NOTICE OF A TYPE I DECISION ON A PROPOSAL IN YOUR NEIGHBORHOOD

CASE FILE NUMBER: LU 19-191336 HR – CHIMNEY REMOVAL

The applicant proposes to remove the existing brick chimney, which is in disrepair and pulling away from the exterior wall. Newly revealed portions of the wall and roof will be patched to match the existing siding and roof material, respectively.

SITE PLAN
 HANEMANN RESIDENCE
 2133 SE 20TH AVE
 PORTLAND OR 97214

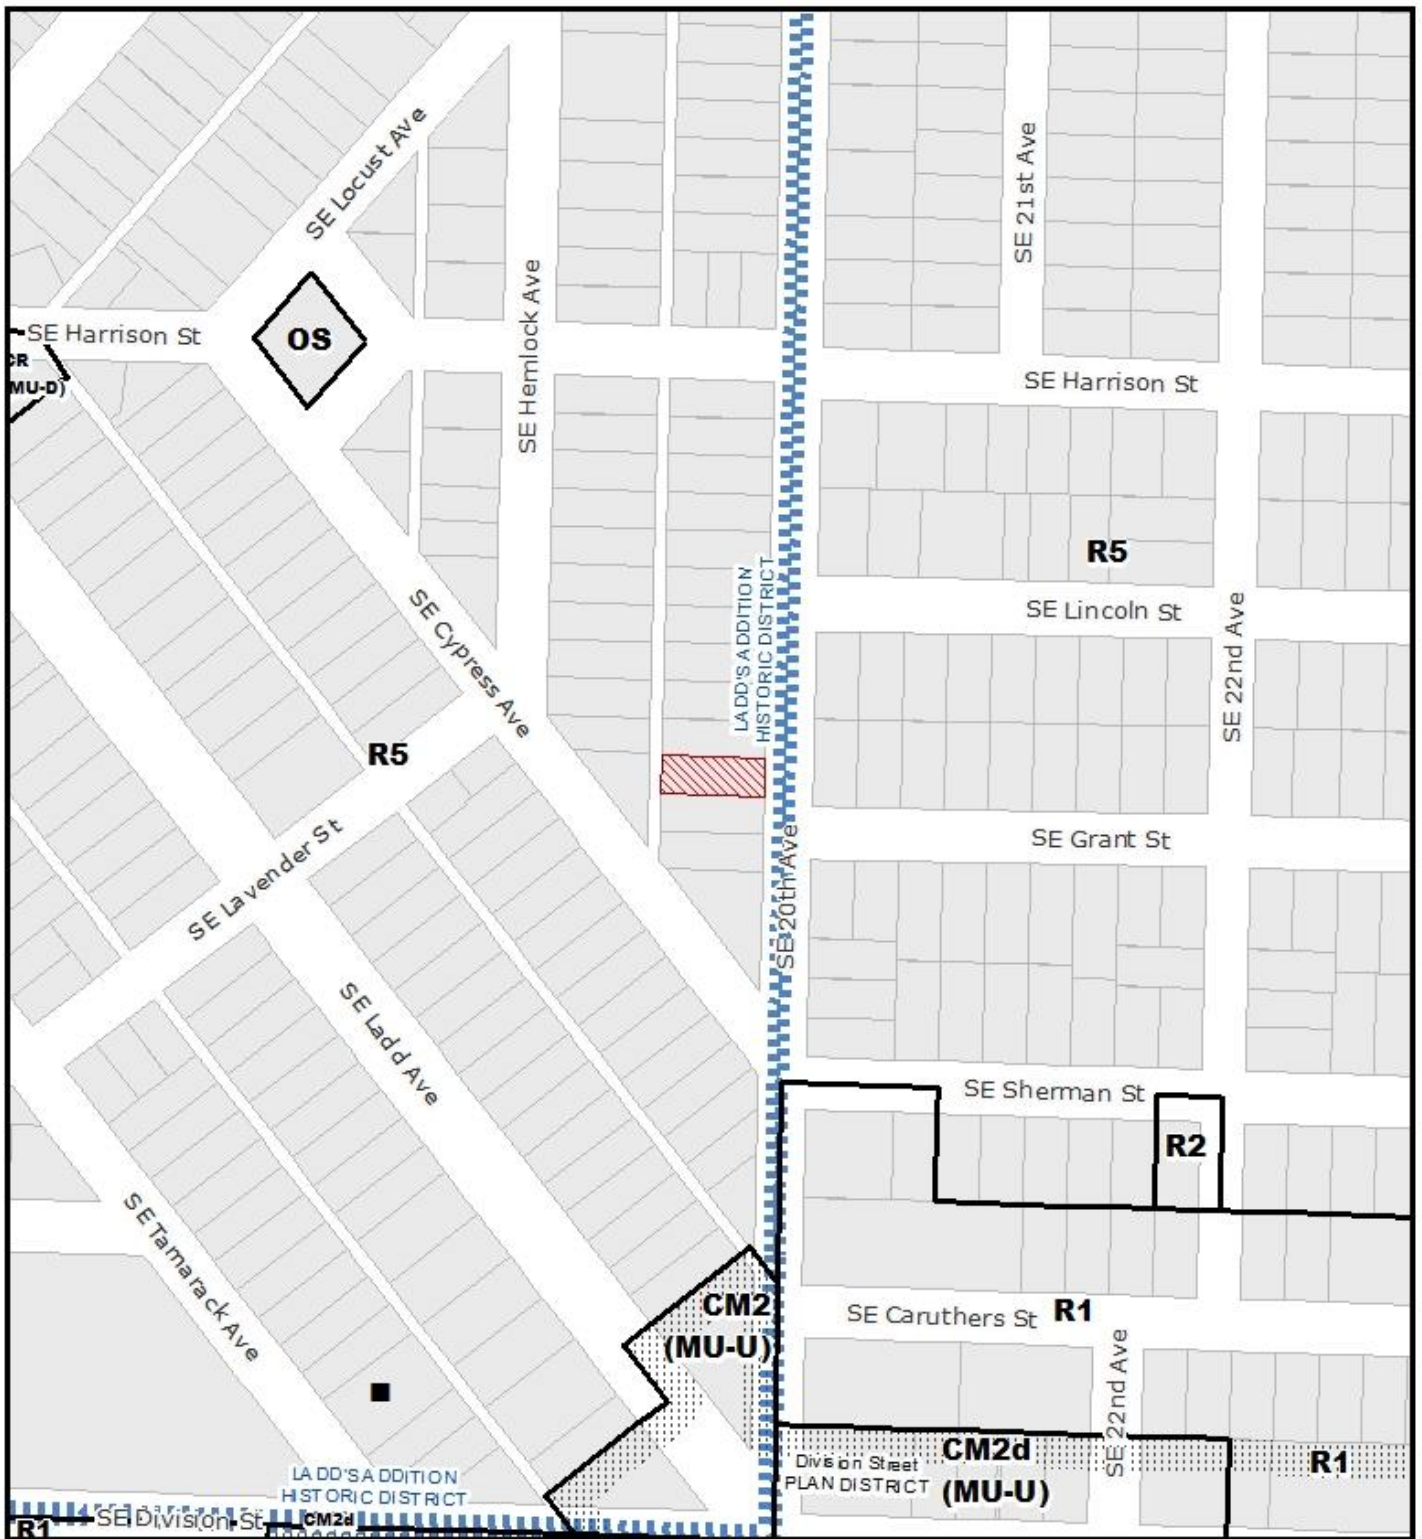
Not Approved

REMOVE CHIMNEY →
